RENESAS TECHNICAL UPDATE

Product Category	MPU & MCU	Document No.	TN-16C-A225A/E	Rev.	1.00
Title	Errata to R32C/118 Group User's Manual: Hardware		Information Category	Technical Notification	
Applicable Product	R32C/118 Group	Lot No.	Reference Document	R32C/118 Group User's Manual: Hardware Rev. 1.10 (REJ09B0534-0110)

This document describes corrections to the R32C/118 Group User's Manual: Hardware, Rev. 1.10. The corrections are indicated in red in the list below.

Figure 8.1 Clock Generation Circuitry

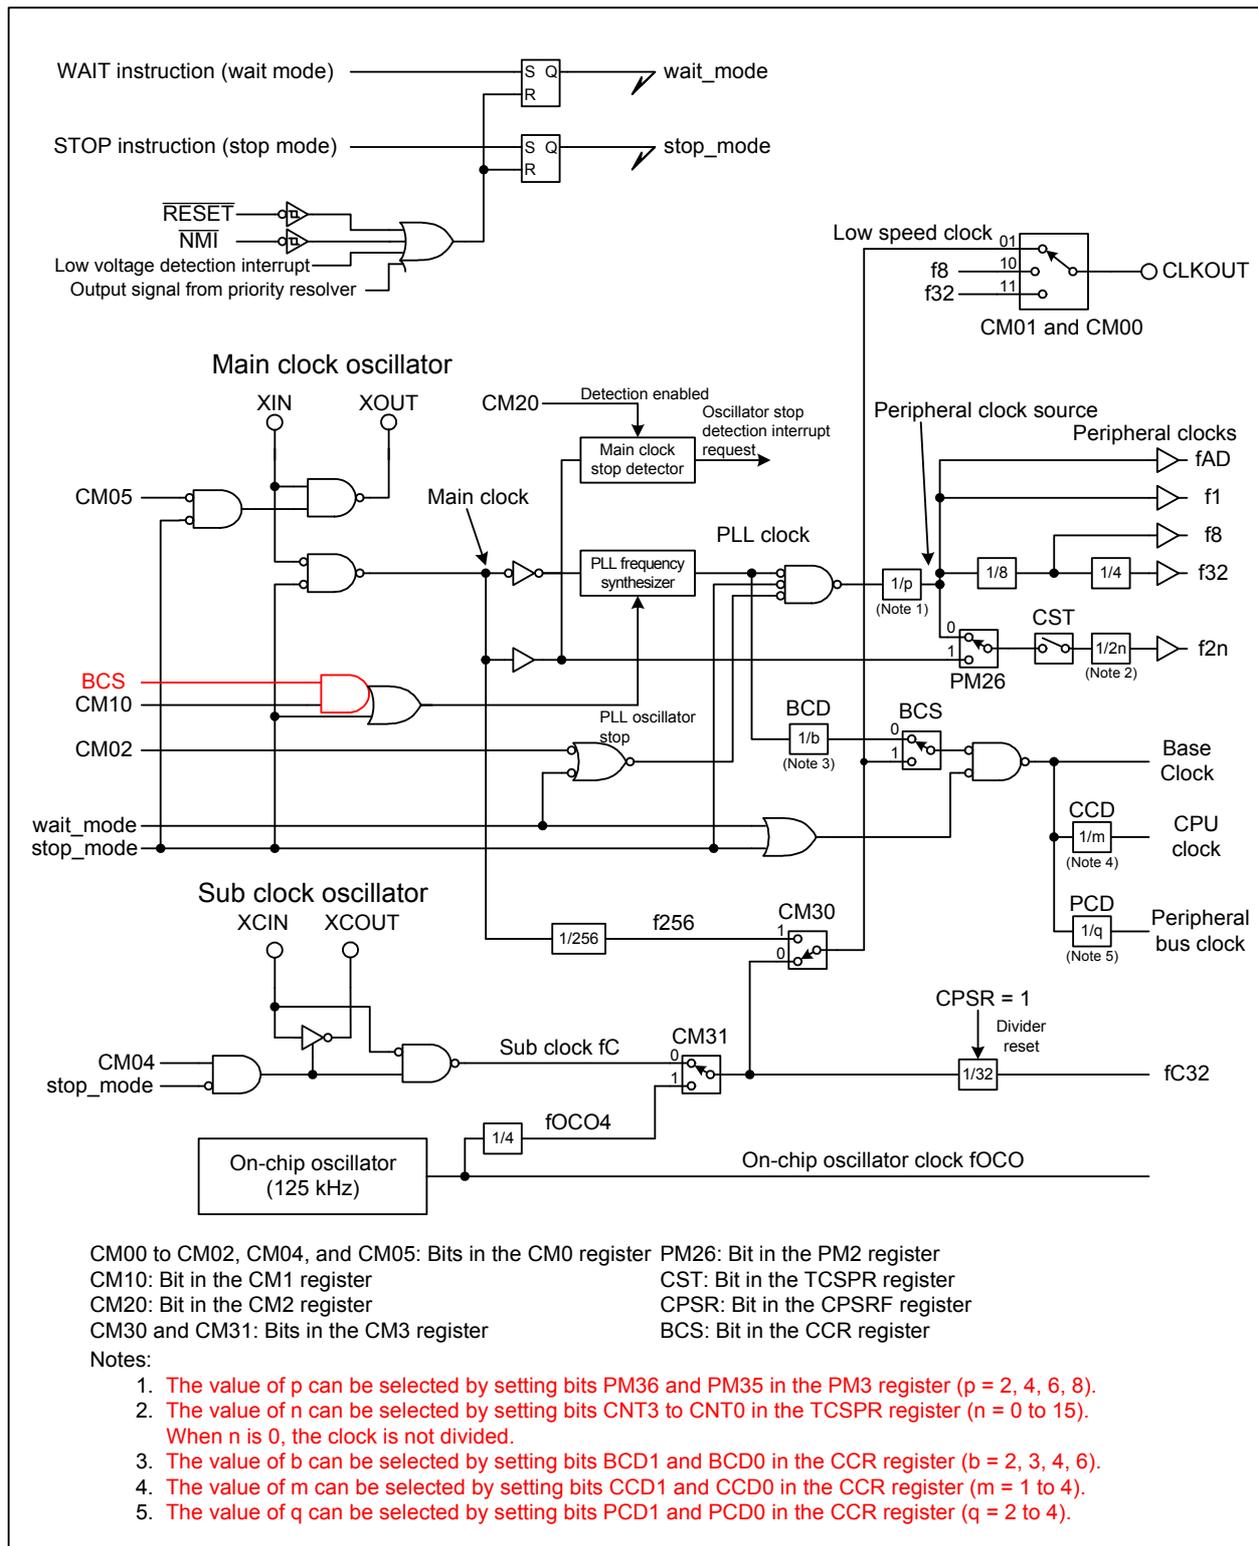
•Page 97 of 618, Figure 8.1 is corrected as follows:

Figure 21.1 CRC Calculator Block Diagram

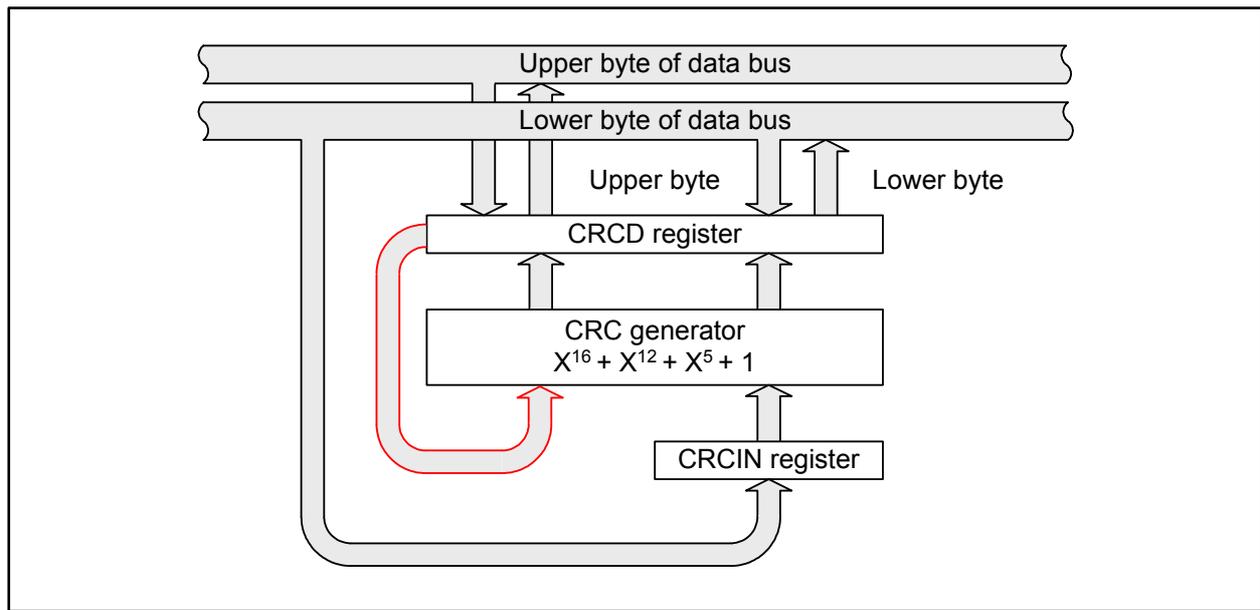
•Page 336 of 618, Figure 21.1 is corrected as follows:

Figure 24.1 Multi-master I²C-bus Interface Block Diagram

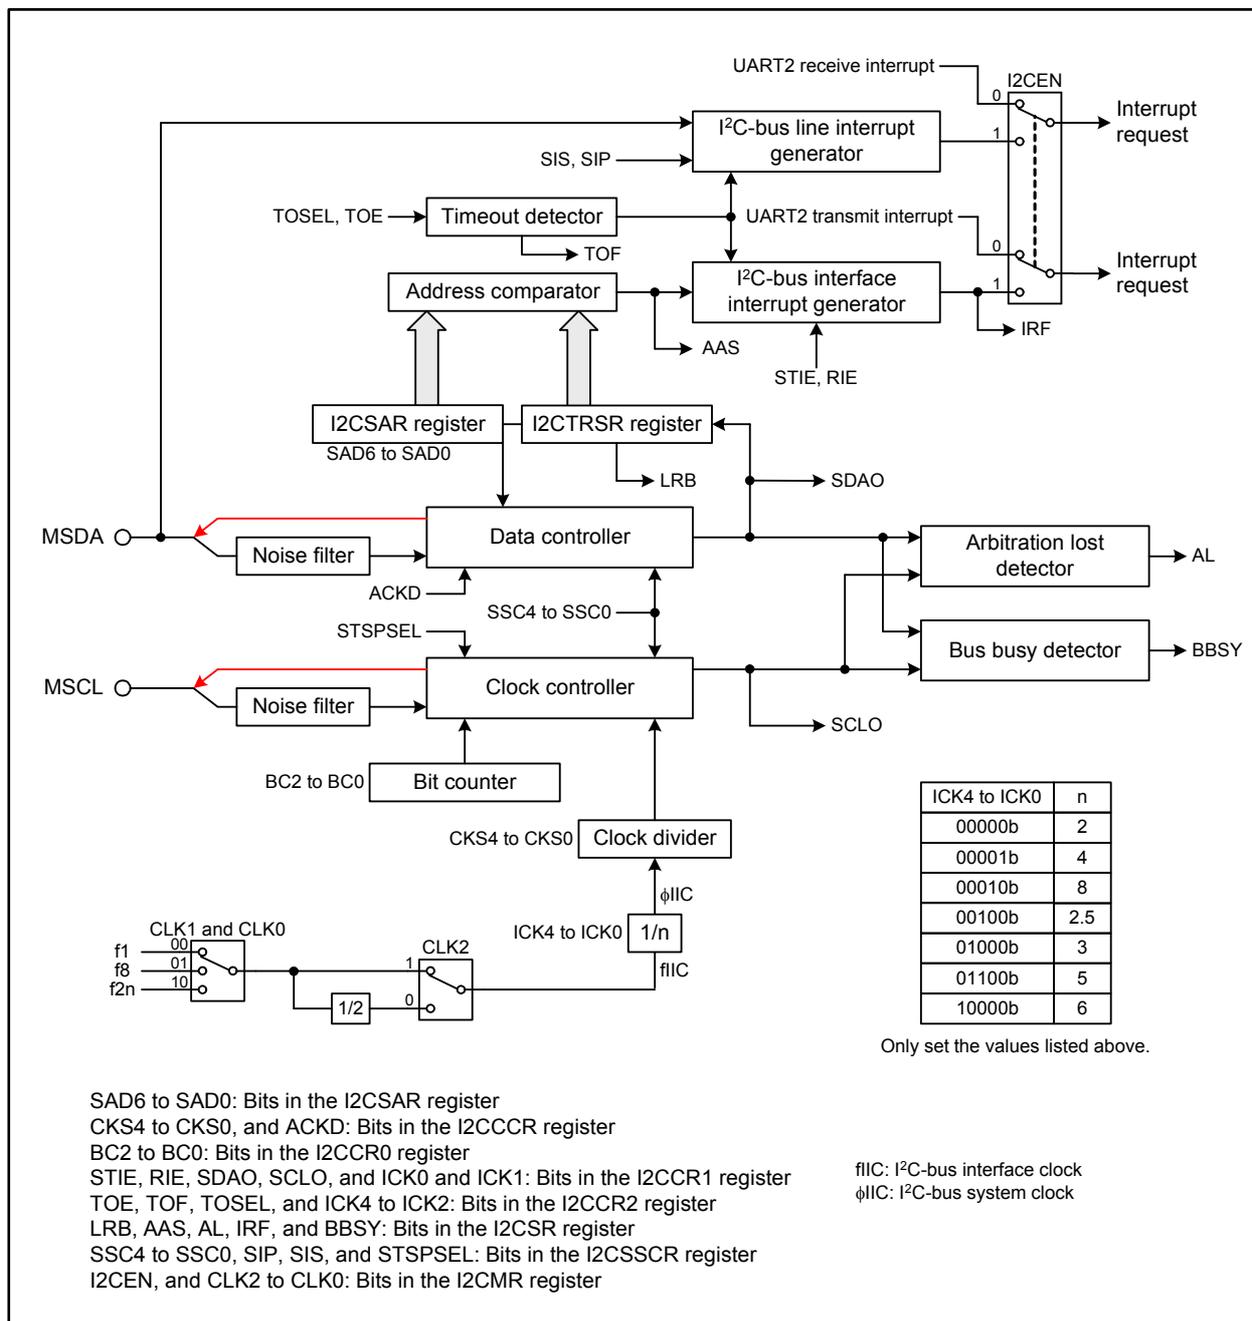
- Page 379 of 618, description “Bits RST2 to RST0 in the G2BCR1 register are set to 000b (base timer is not reset)” in the second dash is deleted from Case 1 in Figure 23.30.
- Page 391 of 618, Figure 24.1 is corrected as follows:

Figure 26.1 Typical I/O Pin Block Diagram (i = 0 to 15; j = 0 to 7)

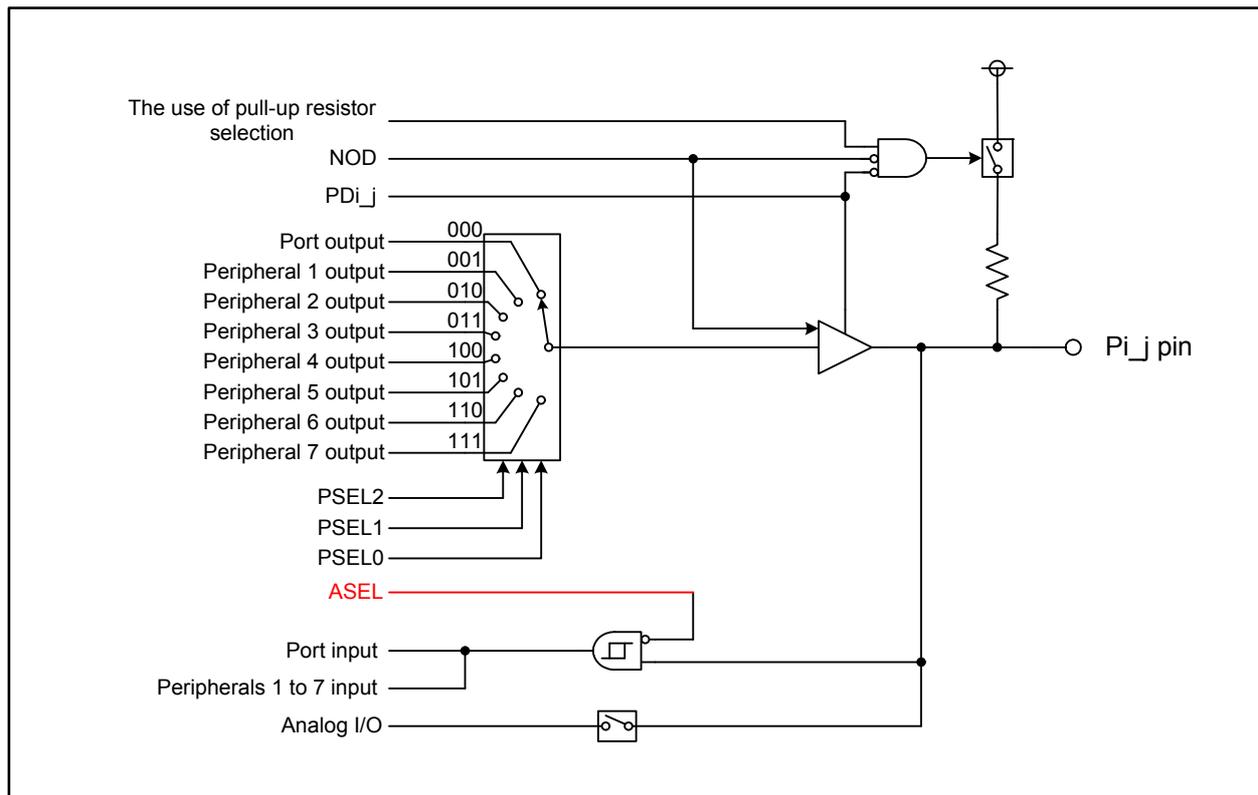
•Page 490 of 618, Figure 26.1 is corrected as follows (refer to TN-16C-A200A/E):
